Proposal for amendments to ECE/TRANS/WP.29/GRE/2025/2

I. Proposal

Figure 1
Landolt ring for measuring the visual acuity

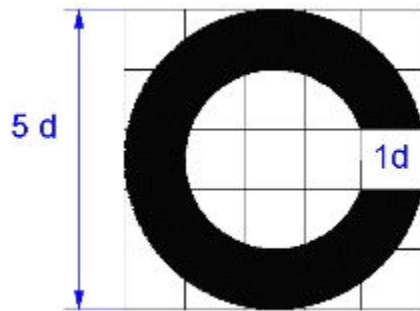
5. In order to have also an objective criterion for the non-identifiability, the size of 12 mm for the character height is added as a footnote. This value is based on informal document GRE-85-16. The visual acuity of a normal observer is defined as the ability to distinguish two objects with a distance of 1' (one arc

minute). At a distance of 10 m, 1' correspond to 3 mm. Consequently, a distance of 2.5 mm is too small to distinguish two objects at a distance of 10 m. In another way, if "d" of the Landolt ring correspond to 2.5 mm, the character height is approximatively 12 mm which ensure the non-identifiability at 10 m.

"*In case of doubt, the character height shall not be more than 12 mm."
